TOLEDO - LUCAS COUNTY PLAN COMMISSIONS

REF: SUP-12002-22

SUBJECT: Special Use Permit for a Day Care Center at 1822 Upton Avenue

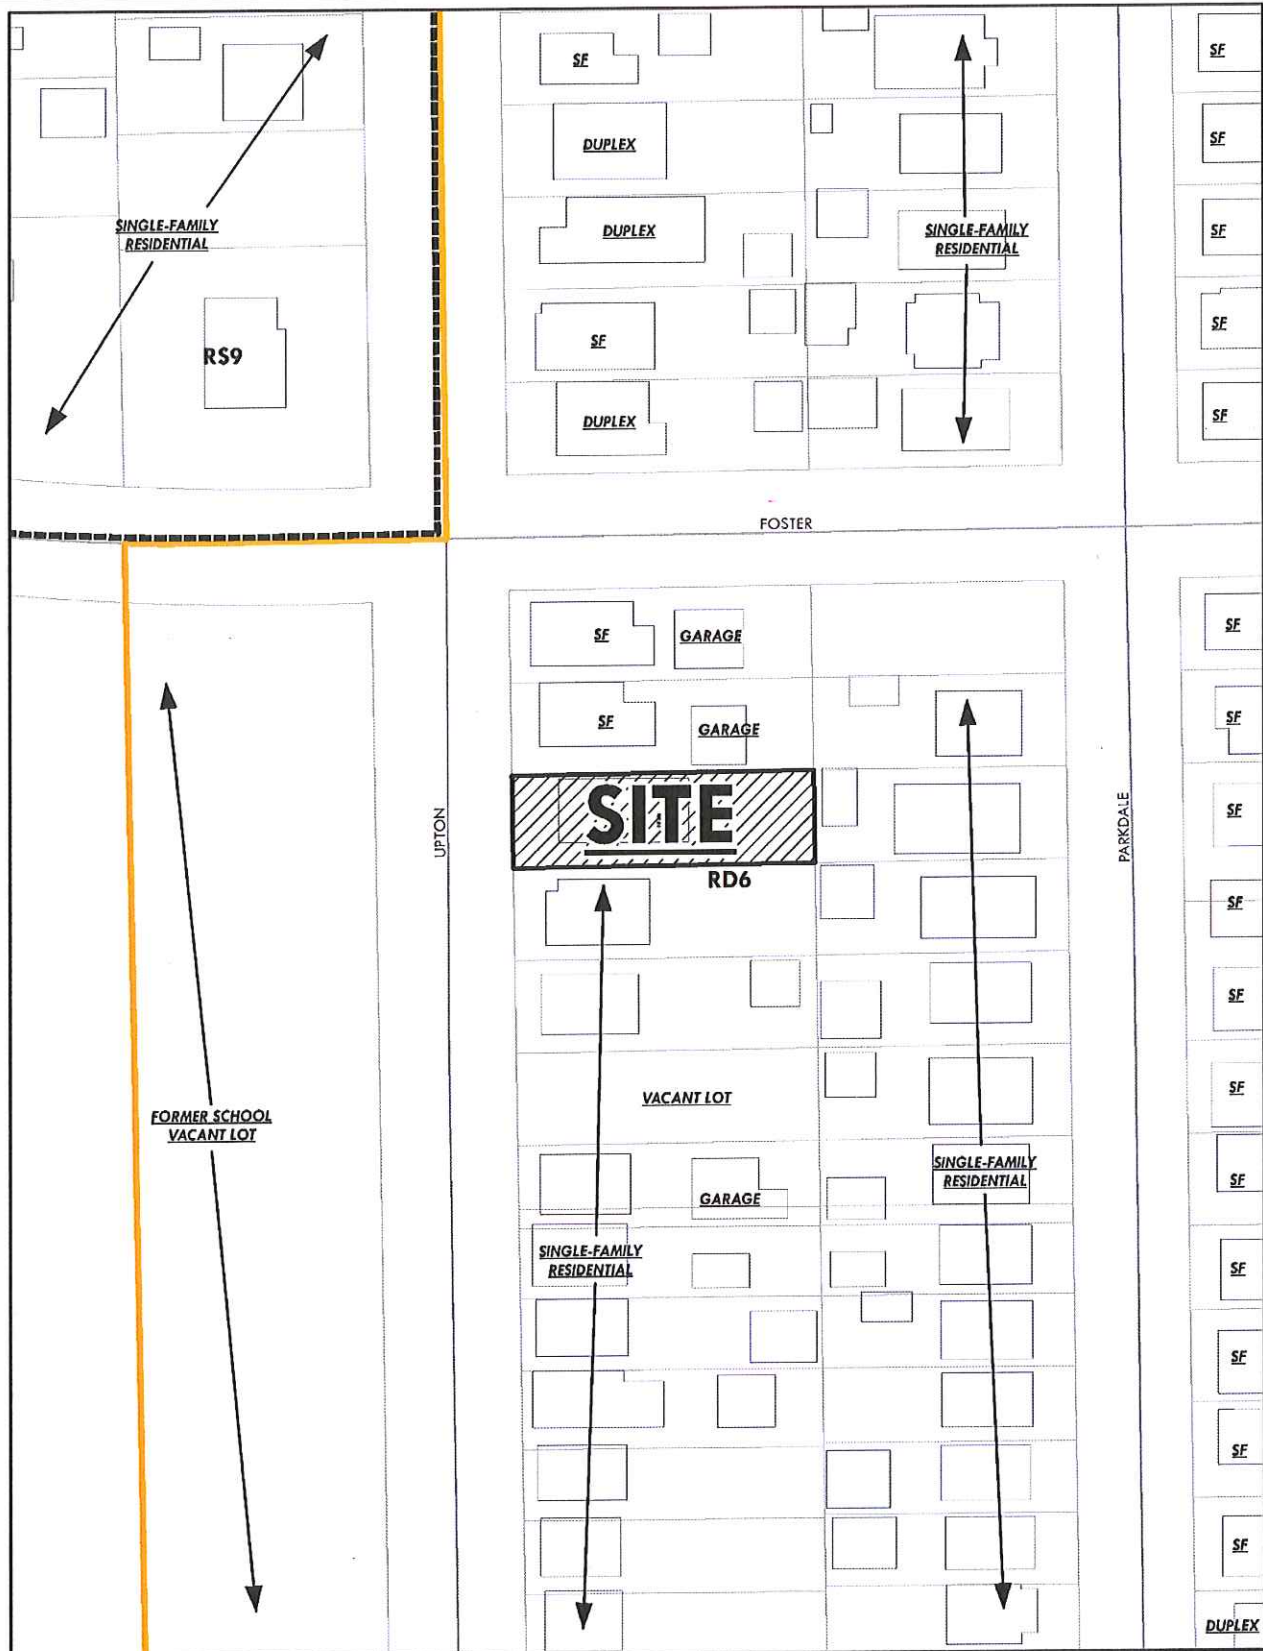
20. Per TMC§1107.0304 a Day Care Center is required to have one (1) parking space per six (6) person-capacity or one (1) parking space per 400 square feet, whichever is greater. A total of three (3) parking spaces are required for the site. The site plan submitted depicts an area available for three (3) parking spaces stacked on a single vehicle width driveway. **Not acceptable as depicted.**

21. A cross-access easement and/or a shared-parking easement shall be recorded for the adjacent driveway at 1818 Upton Avenue to be used as parking.
22. Any spaces reserved for the use by persons with physical disabilities shall adhere to the standards outlined in TMC§1107.1700. One (1) van accessible space is required. **Not acceptable as depicted. One (1) van accessible space shall be shown on a revised site plan.**

23. Per TMC§1107.0400, Off-Street Parking Schedule "A" requires one (1) bicycle parking slot per ten (10) parking spaces. **Not acceptable as depicted. One (1) bicycle parking space is required and shall be depicted on a revised site plan.**

24. Per TMC§1107.1202, no parking space may be located within the front yard, except that parking spaces for detached houses, attached houses, and duplexes may be located on a driveway. **Not acceptable as depicted. The proposed 20'x5' concrete pad in front of the house is not permitted to be used as parking.**

- a. Per TMC§1108.0203(F), a Type B landscape buffer shall be provided around the outdoor space. This buffer shall be a minimum of ten-feet (10') in width and consist of four (4) canopy trees and fifteen (15) shrubs installed every 100 linear feet. Pursuant to TMC§1108.0203(D)(2), a fence, wall, or berm six-feet (6') to eight-feet (8') in height may be used and can substitute for the shrub requirements. **Acceptable as depicted on site plan submitted.**
